ADDENDUM NO. 2**BID NO. 19-07****MIDDLETON ROAD EXTENSION
CITY OF ABERDEEN, MARYLAND**

To all holders of the specifications, the following corrections are hereby made. All other items shall remain unchanged. This addendum shall become part of the Contract Documents for the above referenced project.

- **Section 1: Answers to Questions Posed by Bidders**
- **Section 2: Updated Bid Schedule**
- **Section 3: Crosswalk and Crosswalk Line Detail**
- **Section 4: Revised Construction Drawings**

**MIDDELTON ROAD EXTENSION
LANDSCAPE AND STREET LIGHT PLAN**

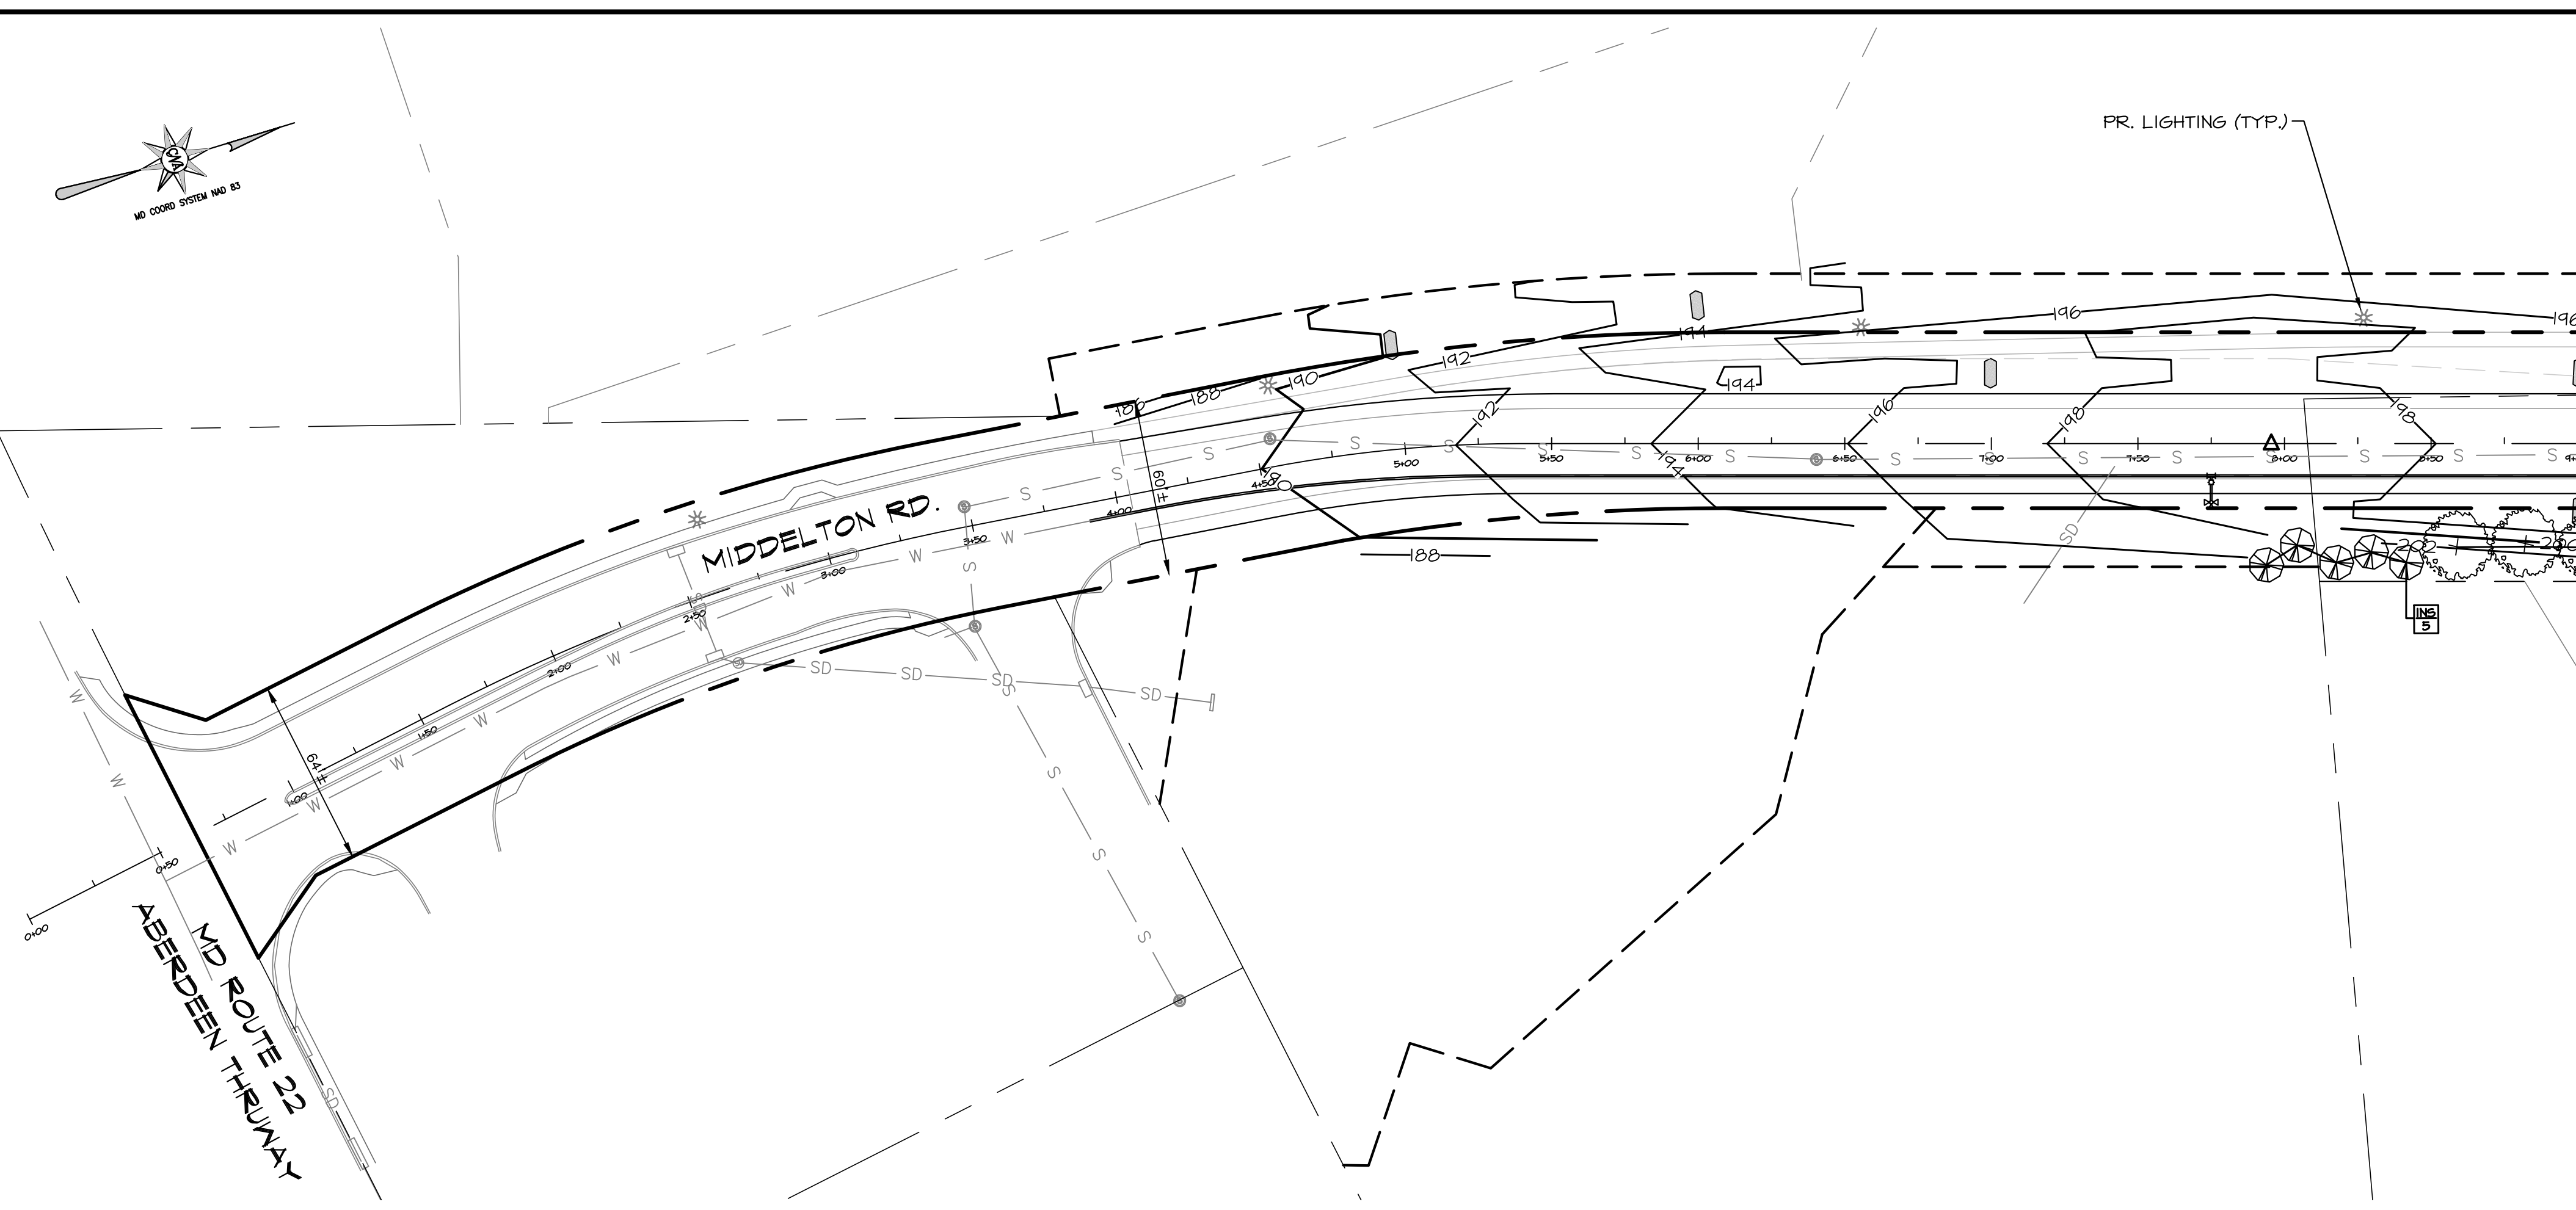
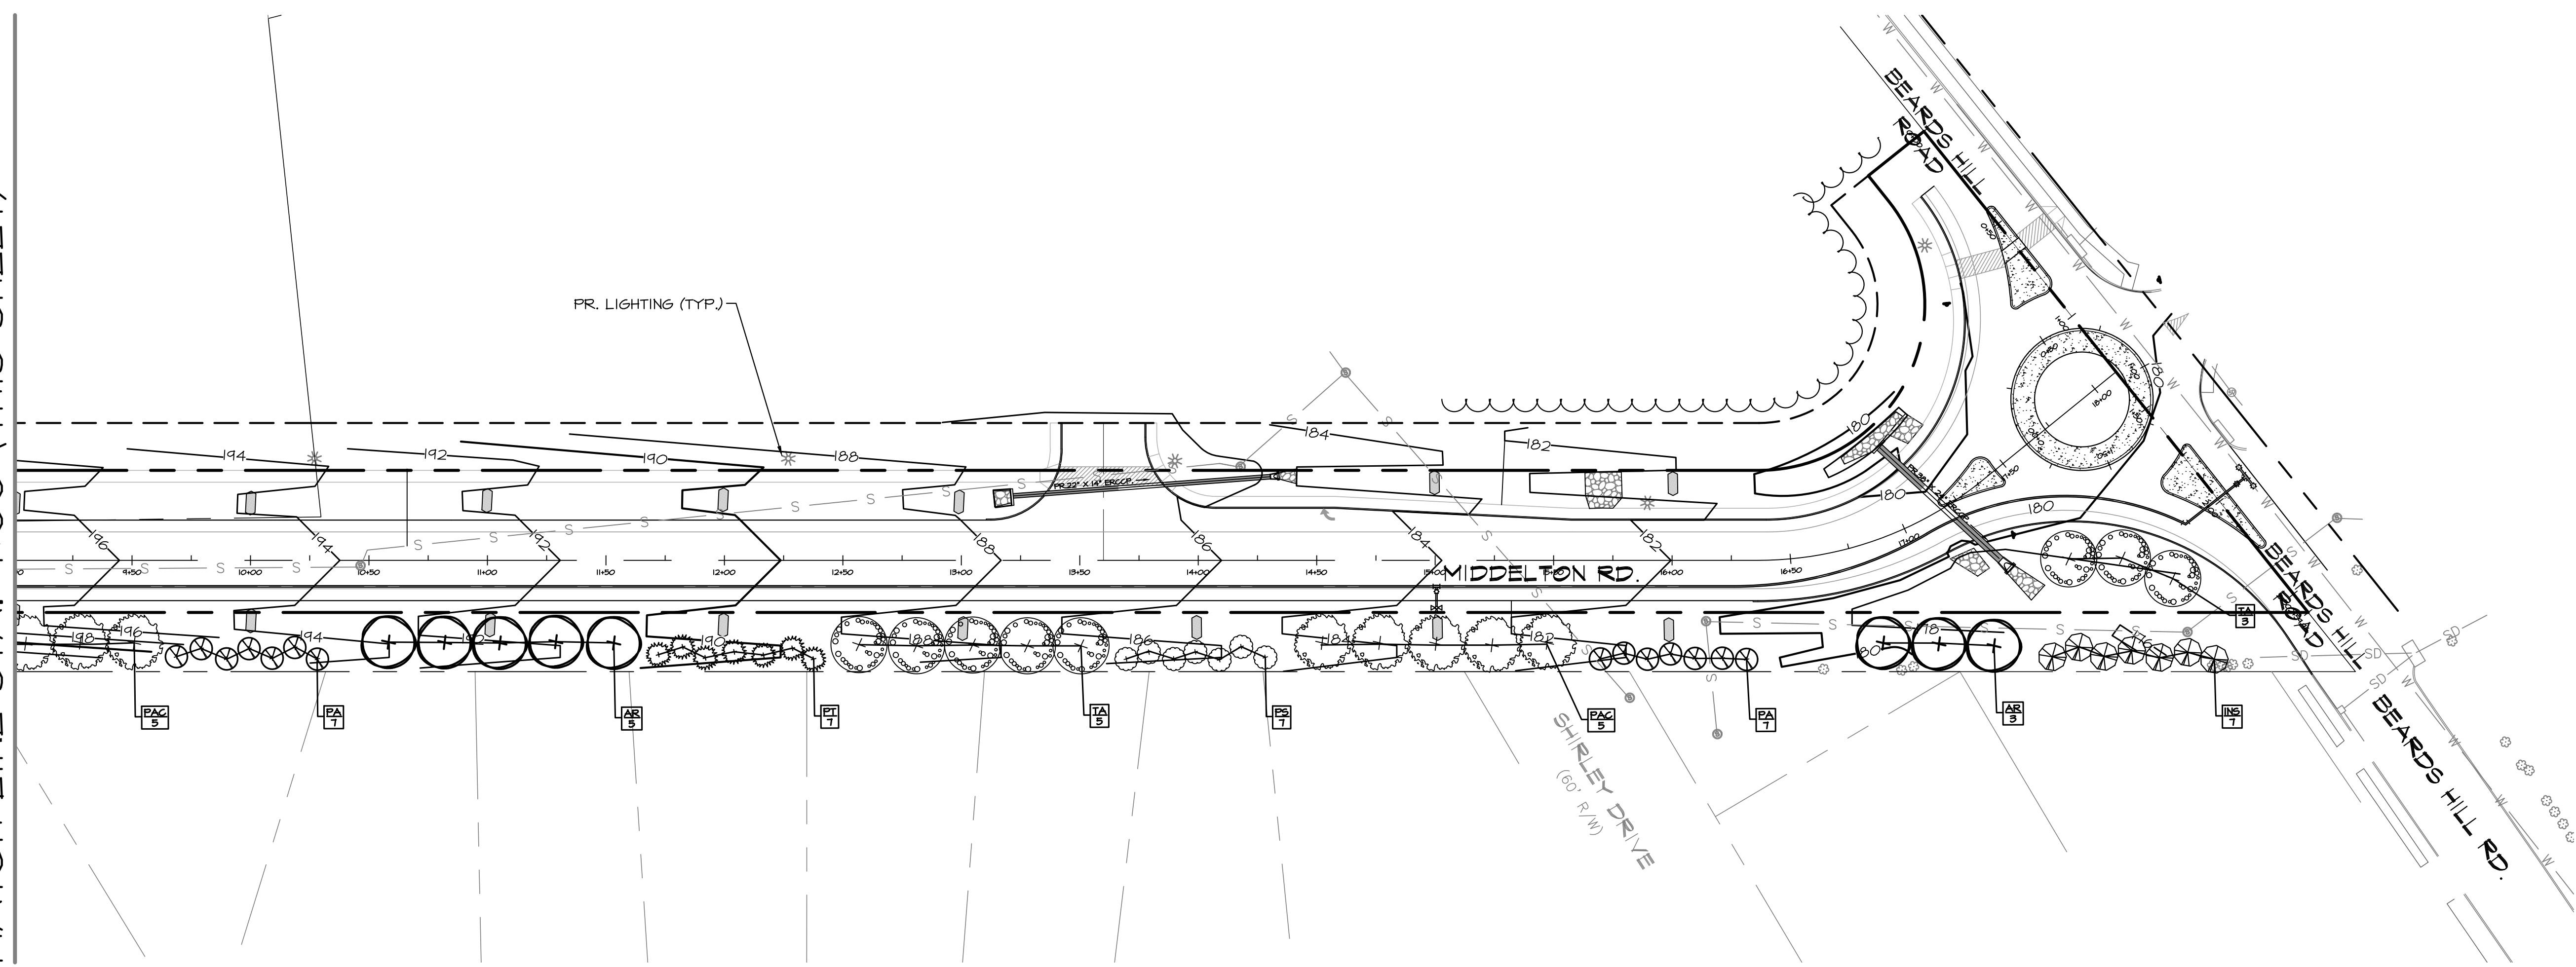
Q15: Sheet 15 – Streetlight schedule – City to resolve.

Q23: Sheet 15 of 15 shows a county street light schedule. Are the lights part of this contract? If so, who is responsible for the conduits and electrical work? Will require specifications of the lights if in fact part of this contract.

A15: This is an open question that needs to be resolved with BG&E.

A23: The lights are not part of the contract at this time.
